Agenda Item # 1

SUB-003653-2026

Brown Square Subdivision

- Subdivision approval to create one (1) legal lot of record from one (1) metes and bounds parcel.

DETAIL SITE PLAN

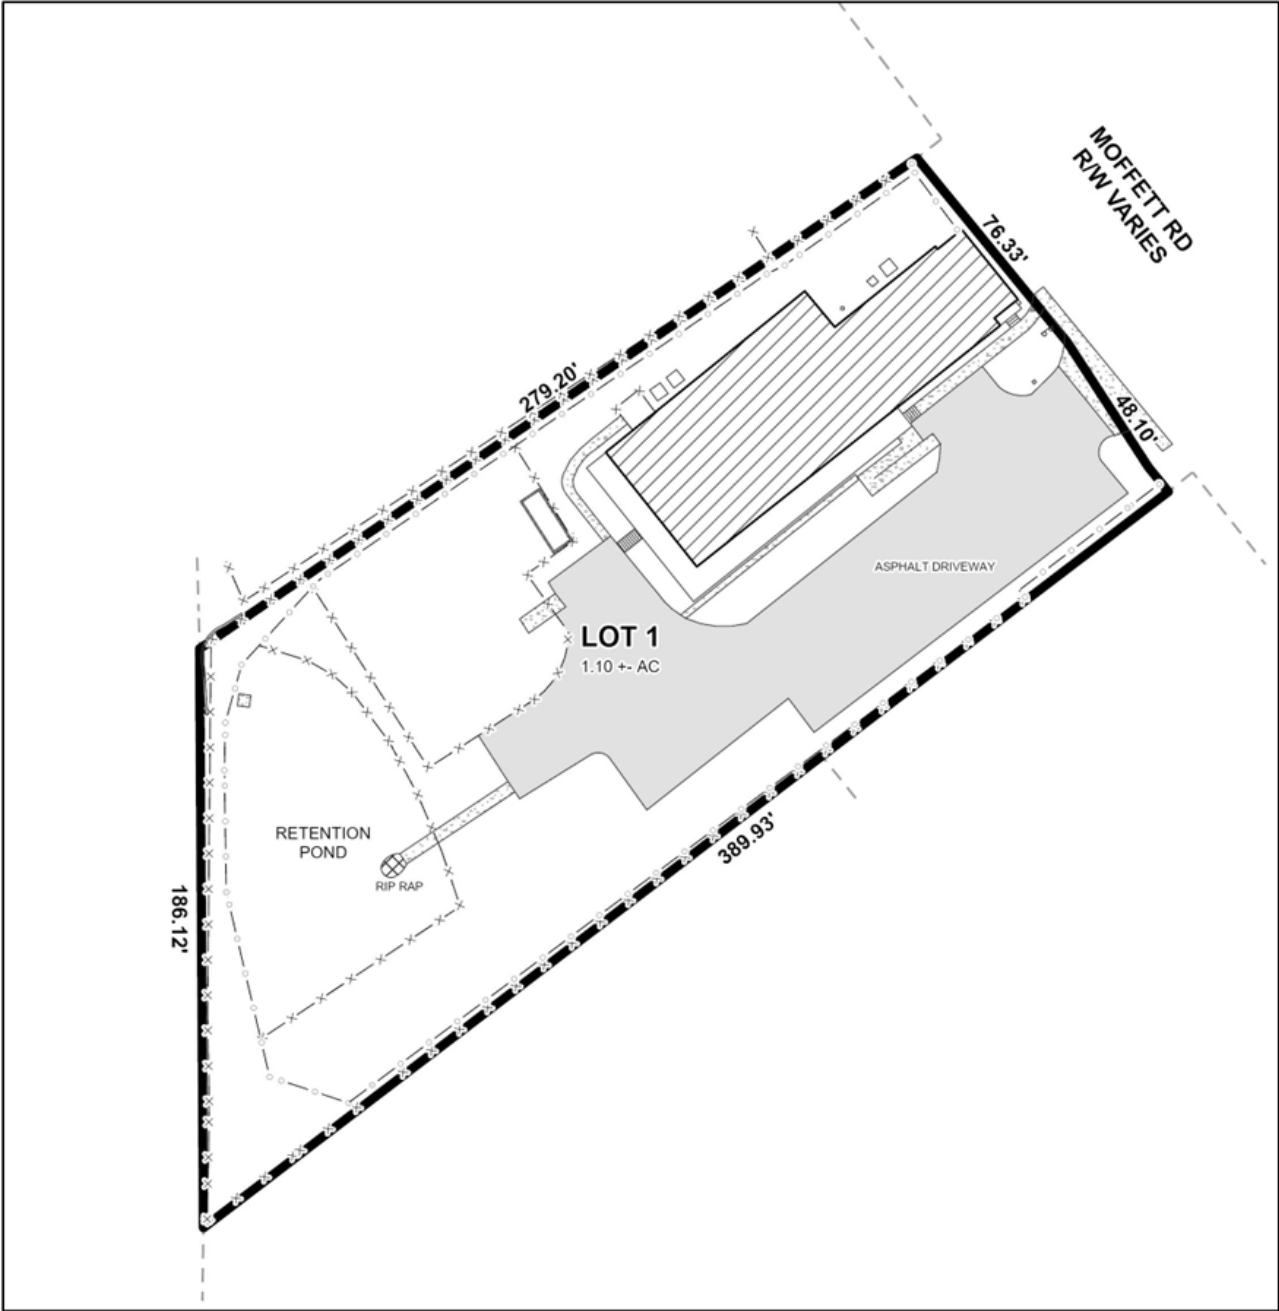
The proposed lot has frontage on Moffett Road, Principle Arterial Street requiring a 100-foot-wide right-of-way at this location. A substandard right-of-way width is depicted on the preliminary plat, making additional dedication necessary. If approved, the plat should be revised to illustrate dedication sufficient to provide 50 feet from the centerline of Moffett Road; however, it should be noted that the existing building would encroach on the right-of-way if dedication is required. As such, a waiver of Section 6.B.9. of the Subdivision Regulations may be necessary.

If approved, the plat should be revised to illustrate the 25-foot front yard setback along Moffett Road, in accordance with Article 2, Section 64-2-14.E. of the UDC and Section 6.C.8. of the Subdivision Regulations. It should be noted that the existing building also encroaches within the required front yard setback and is a nonconforming condition. Future improvements to the building may require compliance with the applicable setback requirements, or the applicant can request a Front Yard Setback Variance from the Board of Zoning Adjustment.

1. Revision of the plat to illustrate dedication sufficient to provide 50 feet from the centerline of Moffett Road, unless a waiver of Section 6.B.9. of the Subdivision Regulations is approved;

2. Retention of the lot's size in both square feet and acres, or the provision of a table on the Final Plat providing the same information;
3. Revision of the plat to illustrate a 25-foot front yard setback along Moffett Road, in compliance with Article 2, Section 64-2-14.E. of the Unified Development Code and Section 6.C.8. of the Subdivision Regulations.
